Development Tribunal – Decision Notice

Appeal number: 26-001

Site address: 81 Park Avenue, North Isis Qld 4660, described as Lot 18 on SP326253 (**Premises**)

Appeal under section 229 and schedule 1, section 1(5) and table 3, item 3(b) of the *Planning Act 2016* (**Planning Act**) against the decision of Council under section 50 of the Plumbing and Drainage Regulation 2019 (**PD Regulation**) to refuse an application to amend a permit for plumbing work for an on-site sewage facility (**Application**).

LAND APPLICATION AREA
PLAN No. 73095.001

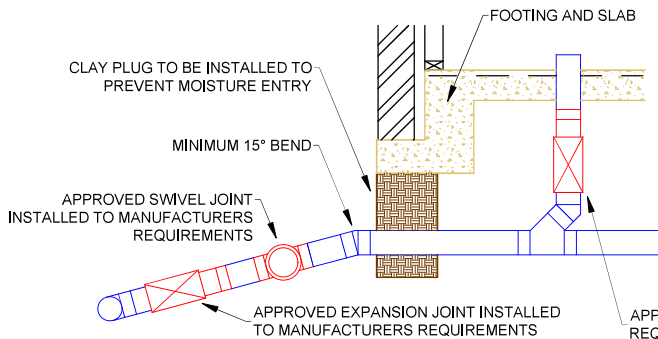
- (b) Condition (2)(b): The land application area is to locate in the area depicted on approved plan No: 73095.001;
 - (c) Condition 2(c): The qualified wastewater system designer is to provide a technical note detailing how the wastewater design responds to flood risk for land in a Council adopted Flood Hazard Area, and meeting the performance standards of AS/NZS 1547, the Queensland Plumbing and Wastewater Code and the Plumbing and Drainage Act 2018.

- (b) Permit condition 2(b) Land Application Plan No. 73095.001 shows the requirement for a 4m setback from the existing shed. The 4m down slope rule from footings of buildings and structures is only applicable to subsurface land application areas as per the QPW Code, Part 2, Table T2. Table T3 setback distances for surface irrigation have no mention of requiring a 4m separation distance. The current design shows a 3.150m separation distance from the shed and is compliant with the QPW Code;

- 160. The Tribunal therefore decides to approve the Application in accordance with the attached Compliance Permit with the changes marked in red deleting conditions 2(a), 2(b) and 2(c) and Land Application Area Plan No. 73095.001.
